UNITED STATES PATENT AND TRADEMARK OFFICE

10/666,074

Office Action Summary	Application No. 10/666,074	Applicant(s) JACKSON, ROGER P.	
	Examiner Anu Ramana	Art Unit 3733

DETAILED ACTION

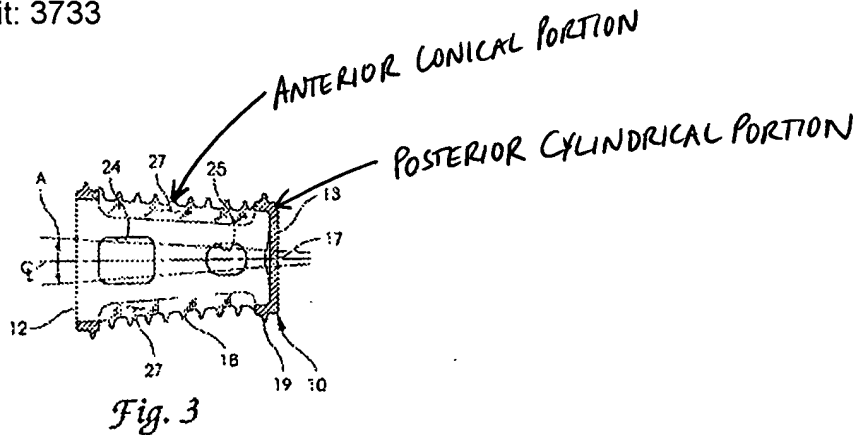
Zdeblick et al. disclose an interbody fusion device including an anterior conical portion, a posterior cylindrical portion joined to the anterior conical portion at the converged end of the conical portion and partial thread members extending radially outward from the conical and cylindrical portions (Figs. 3, 8A and 14(d), col. 5, lines 41-59 and col. 12, lines 21-34). See marked up Fig. 3 from Zdeblick et al. on the following page.

Zdeblick et al. disclose all elements of the claimed invention except for anterior threads extending outwardly from the anterior conical portion for at least two revolutions and posterior threads extending outwardly from the posterior surface for at least two revolutions.

At the time the invention was made, it would have been a matter of obvious design choice to a person of ordinary skill in the art to provide anterior and posterior threads extending for at least two revolutions because Applicant has not disclosed that providing at least two revolutions of anterior and posterior threads provides an advantage, is used for a particular purpose, or solves a stated problem. It would have been prima facie obvious to modify Zdeblick et al. to obtain the invention specified in claims 1, 9, 16, 26 and 28 because such a modification would have been considered a mere design consideration which fails to patentably distinguish over the prior art of Zdeblick et al.
